CITY OF HIGH POINT

Title: Change Order No. 8 - Richland Creek Sewer Outfall Aerial Sewer Pipe Replacement Project, Garney Companies Inc.

Subject: Richland Creek Aerial Sewer Replacement Project – Repairs & Modifications to Aerials related to Thermal Expansion of Pipe

Pictures showing the pipe movement inside of the manholes and pull-out damage to the manhole rubber boot.

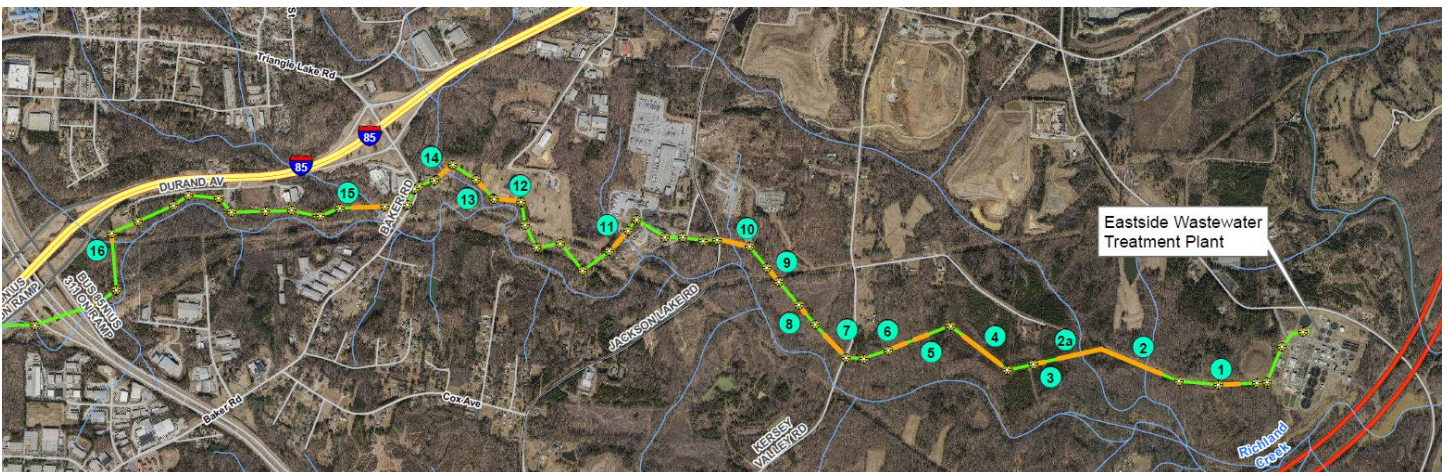
This Change Order will incorporate changes to the Richland Creek Sewer Outfall project to correct expansion and contraction issues of steel pipe at the manholes. It is determined that an additional rigid restraint will be required between the expansion joints and manhole at Aerials 1 through 15, totaling 23 locations. Work will include the appropriate lining and coating repairs and subsequent bypass pumping requirements.

Exhibit showing proposed reinforced concrete thrust blocking with steel saddle installation between the expansion coupling and the manhole.
